Argyll and Bute Council

NOTICE OF MEETING

1. **APOLOGIES FOR ABSENCE**
2. **DECLARATIONS OF INTEREST**
3. **CONSIDER NOTICE OF REVIEW REQUEST: VARIATION TO A CONDITION RELATIVE TO PLANNING PERMISSION REFERENCE 20/00267/PP AT LAND SOUTH OF HIGH OAKS, ARTARMAN ROAD, RHU, HELENSBURGH - PREVIOUSLY ISSUED PAPERWORK**

LOCAL REVIEW BODY REFERENCE 22/0001/LRB**PLANNING APPLICATION 21/01603/PP****VARIATION OF CONDITION 7 RELATIVE TO PLANNING PERMISSION REFERENCE 20/00267/PP TO REDUCE THE CONDITIONED VISIBILITY SPLAY FROM 2.4 X 42 X 1.05M TO 2.4 X 17 X 1.05M****COMMENTS ON BEHALF OF THE LOCAL PLANNING AUTHORITY****BACKGROUND:**

APPENDIX B – PLANNING PERMISSION 20/01190/PP – SITE PLAN

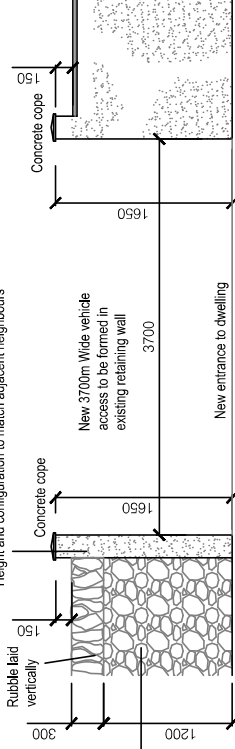
Planning Ref: 20/01190/PP was approved for a new vehicle access to a new dwelling house in Torwoodhill Road. Please refer to enclosed Appendix B which shows the approved plan along with recent site photographs. The approved drawings clearly demonstrate a failure to provide visibility splays as 1.65m high gate posts obscure any sight lines. The location of adjacent entrances is also contrary to advice previously provided to an option we explored at Artarman road. From a site visit it is clear that this new entrance also does not have a level entry as required under the current roads guidance. The information on the Planning Portal shows a varied report from roads which removes the sightline requirement – there is no explanation as to the reason for this change, Planning advised that it had followed a site visit?

The position of this property on a dead end road is almost identical to our application, however our proposal provides a level entry, clear (but slightly reduced) sightlines and widened main access road. All of these items combined provide a far superior & 'safer' exit onto a public road.

APPENDIX C – PLANNING PERMISSION 19/02604/PP – SITE PLAN

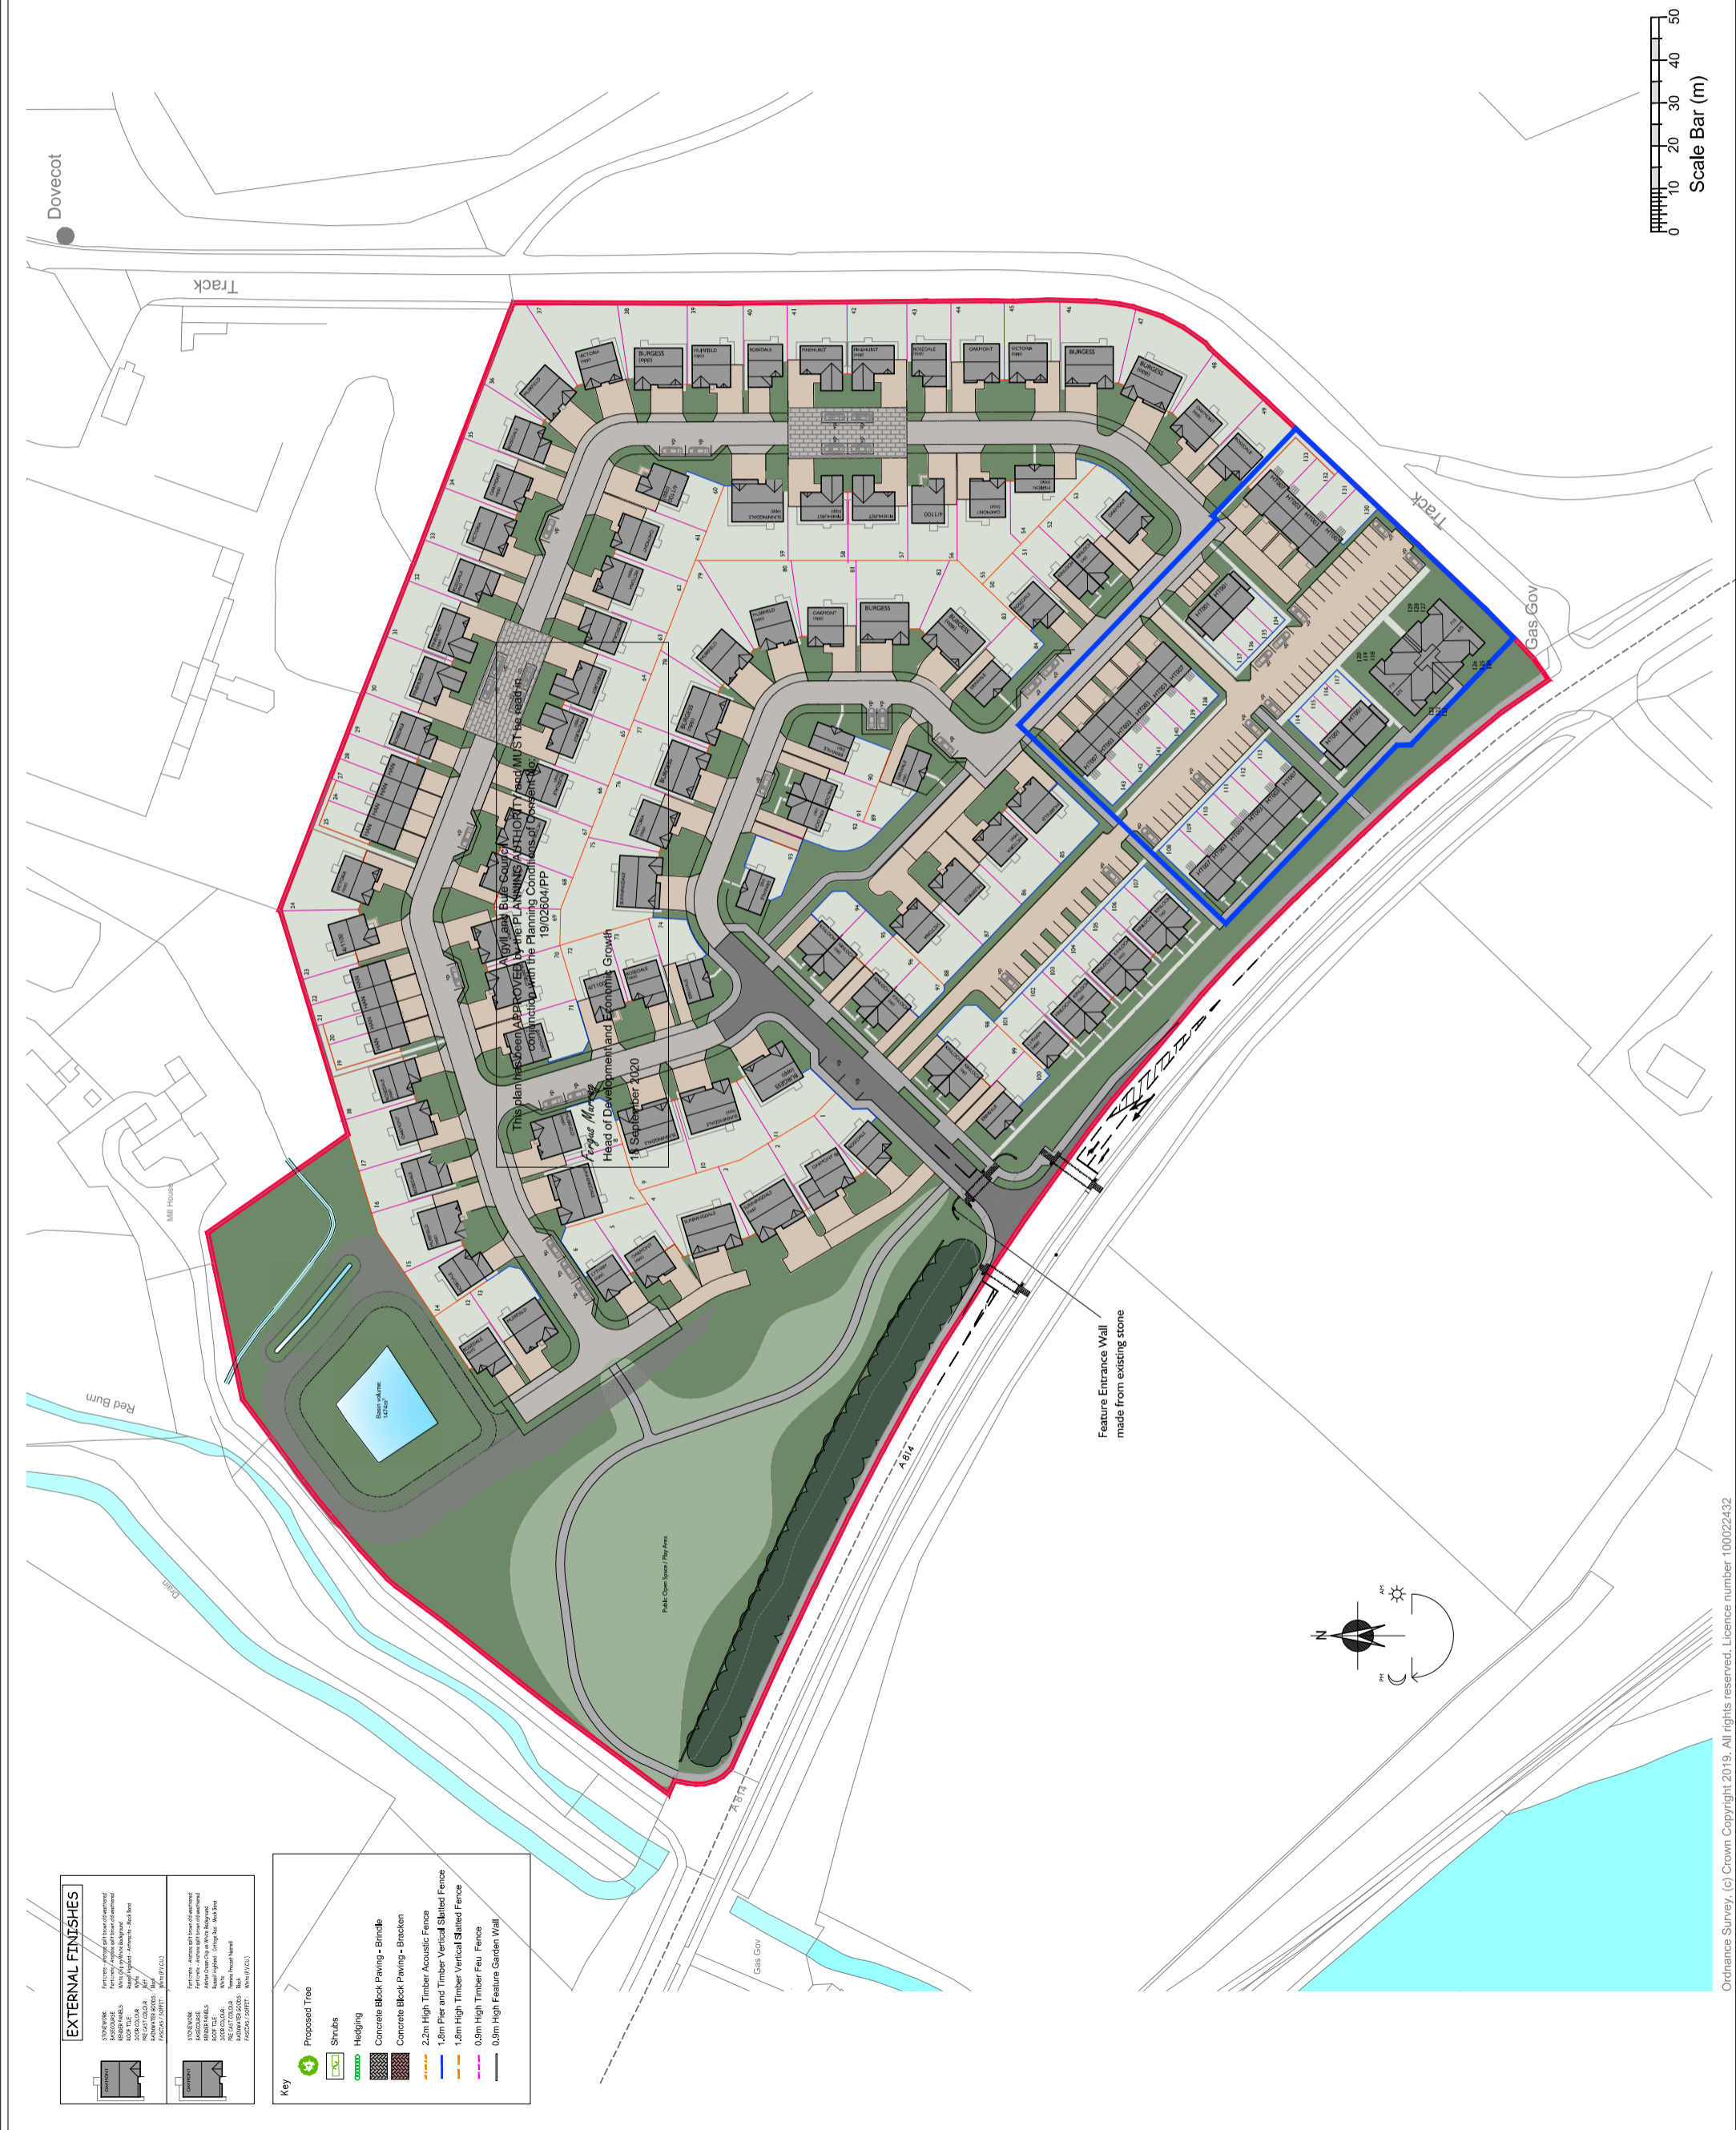
Planning Ref: 19/02604/PP was approved for 143 Houses/ Flats on land East of Hermitage. The roads report contains limited comments on this proposal around vehicular access from the dwelling houses. Looking at the approved site plan and extracts (Appendix C) we are at a loss as to why it is acceptable to allow a multi-unit new build development to have driveways off the main access road which then involves you having to reverse across a footpath into oncoming traffic yet in a single new build dwelling this is not permitted, and where this manoeuvre is seen as being safer than being able to enter and exit a driveway in a forward gear?

The extract below is from the proposed Bellway site at land East of Hermitage Academy, which obtained planning consent in September 2020 – this approved proposal appears to indicate not only private driveway exits reversing over public footpaths but also internal courtyard parking exiting as a pavement crossing. In addition to the close proximity of driveways to junctions etc.

APPENDIX B – ECS SITE ACCESS/ VISABILITY SPLAY DRAWING

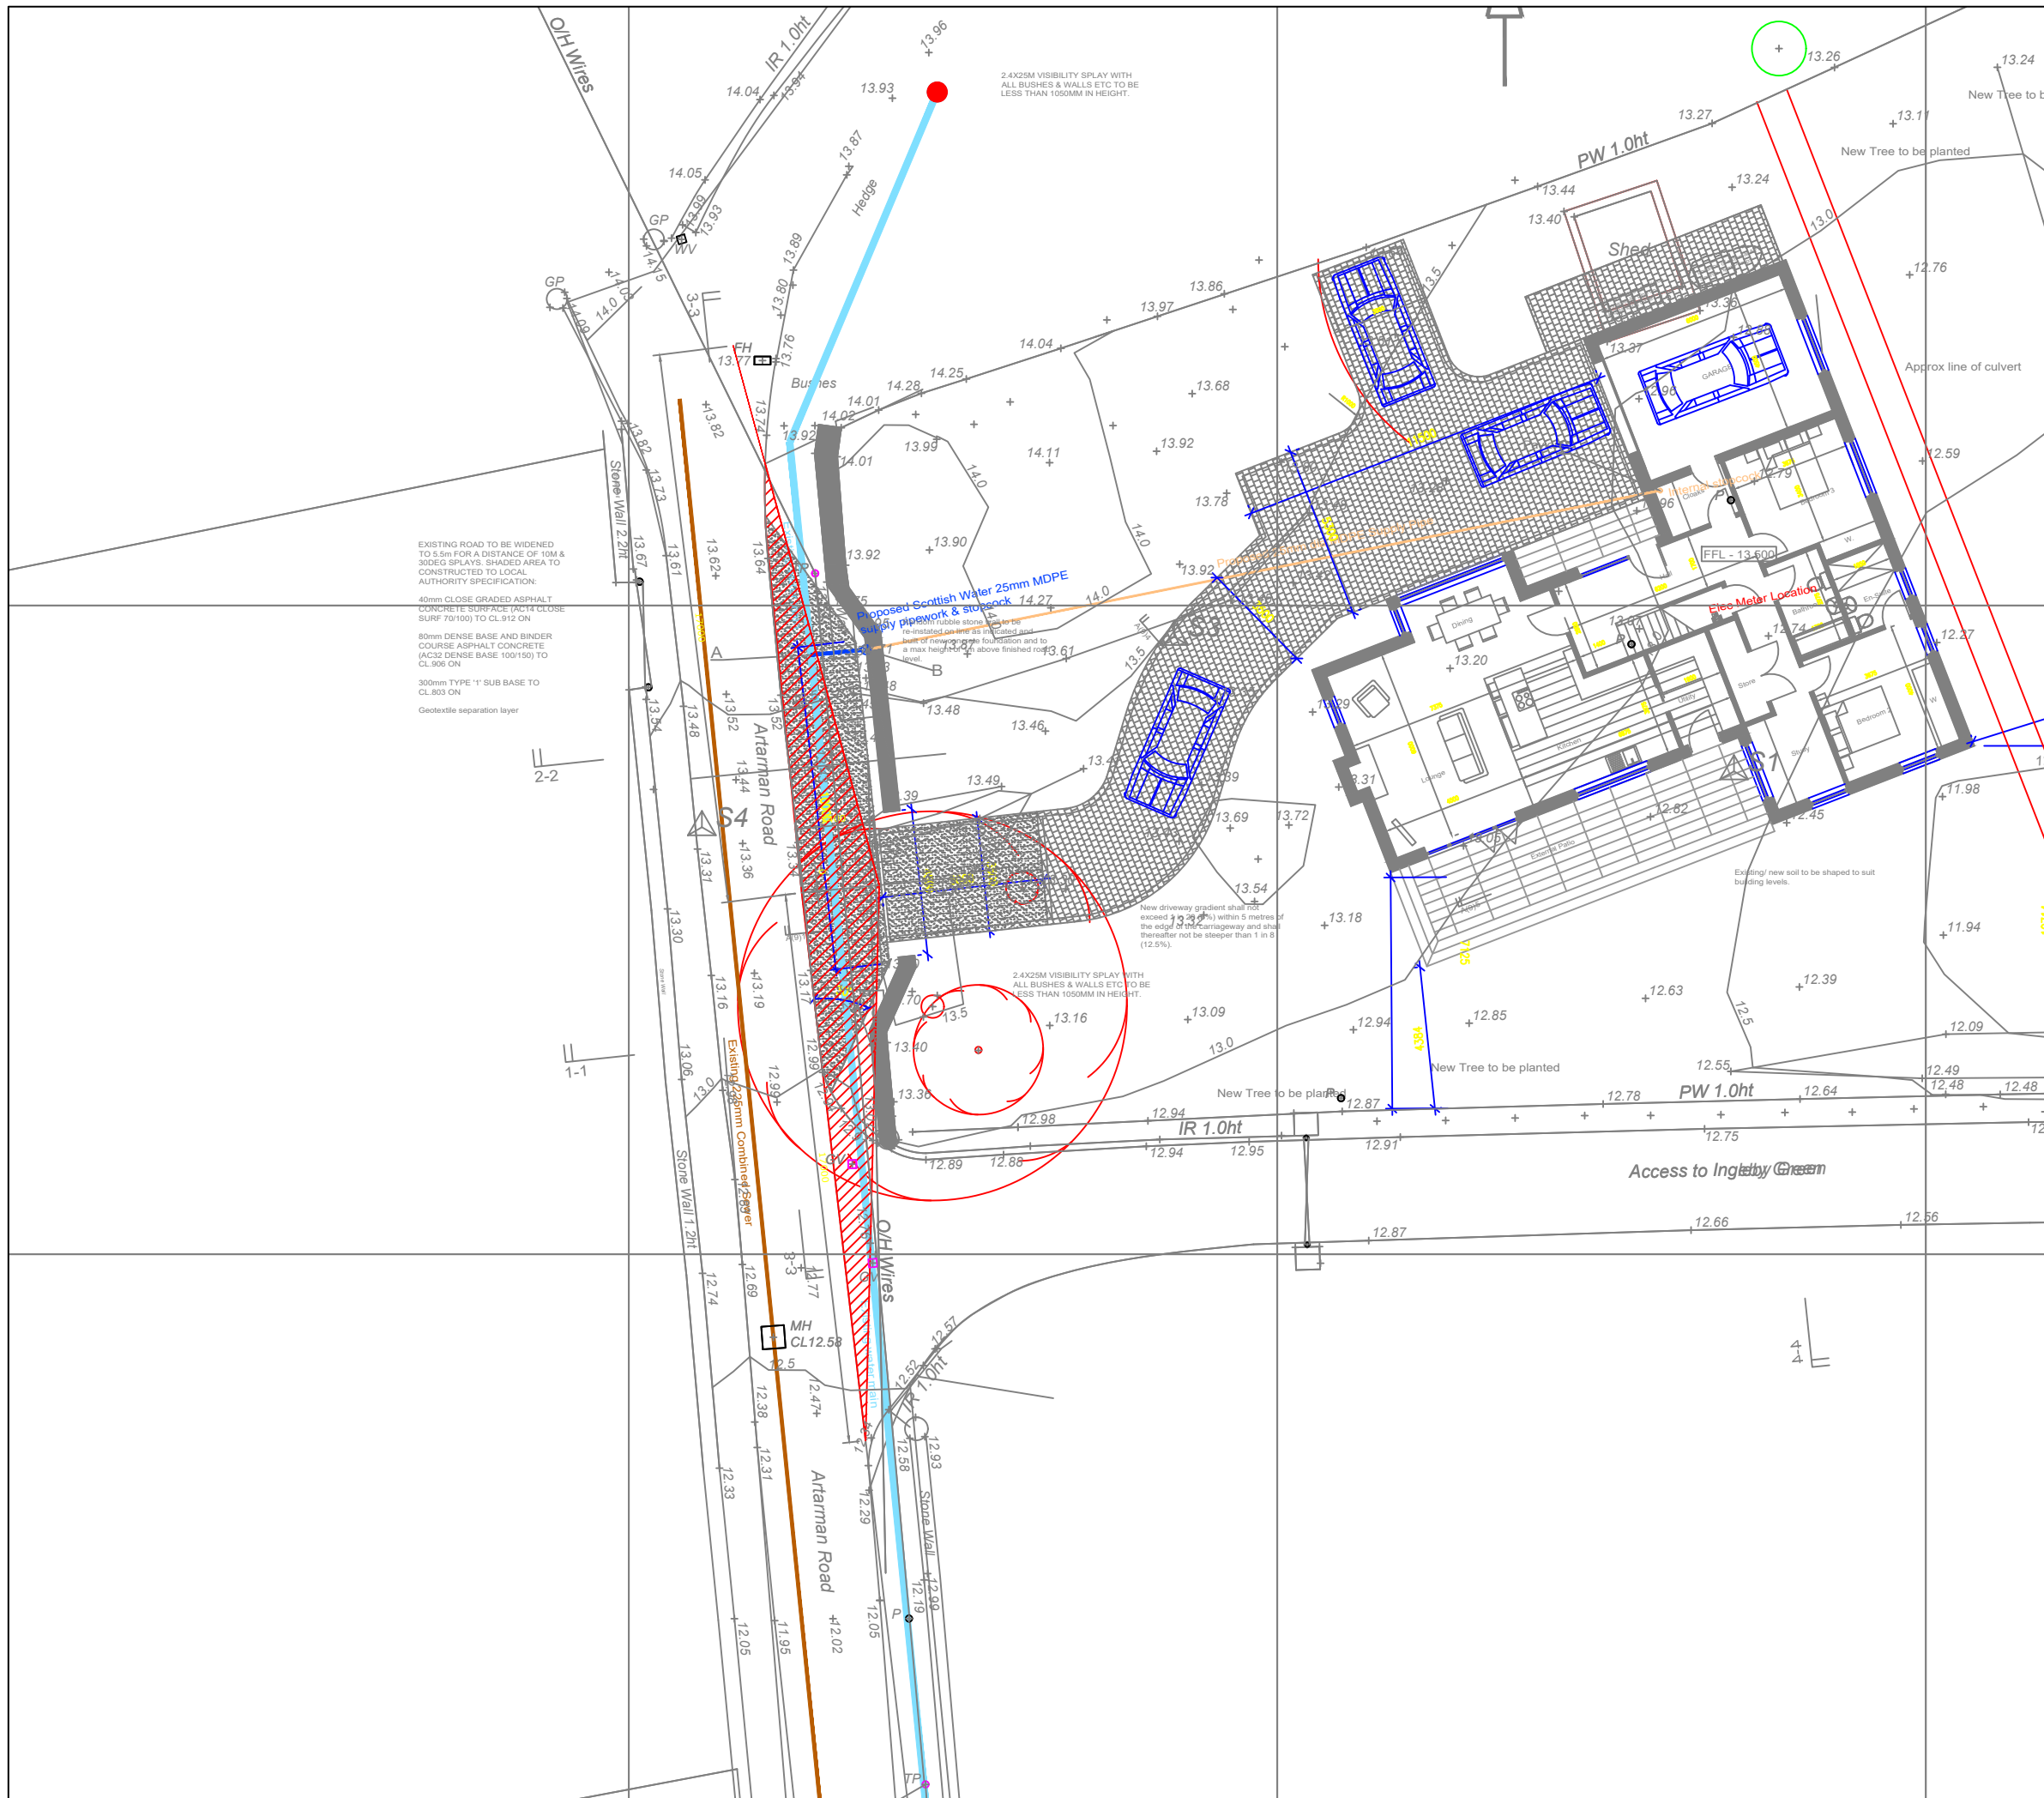
ECS drawing 21054-001 contained within *Appendix B* indicates that the required visibility splay as per the guidance contained within the Designing Streets policy document can be achieved, however, the Y distance is measured to the centre point of the carriageway to avoid third party land to the north. As Artarman Road is a single carriageway road the proposed splay will still ensure that all vehicles negotiating the route are visible from the proposed access thereby confirming that there is no reduction in the visibility envelope proposed.

The visibility splay achievable from the proposed access meets the required of the measured road speed therefore it is considered that Condition 7 of the planning consent should be amended to reflect this submission.

The applicants thereby seeks the rewording of Condition 7 to reflect the visibility splay demonstrated within ECS drawing 21054-001.

In the interests of road safety the refusal should be upheld as the reduction in the visibility splay from the agreed 2.4 x 25 x 1.05m to 2.4 x 17 x 1.05m would result in an unacceptable level of risk to the public. This is due to the proposed access being in close proximity to the bend in Artarman Road and therefore, a minimum visibility splay of 2.4 x 25 x 1.05m is required. The access is therefore detrimental to the interests of road safety and is contrary to the provisions of Policy LP TRAN 4 of the 'Argyll and Bute Local Plan', as a satisfactory means of vehicular access cannot be achieved at this point.
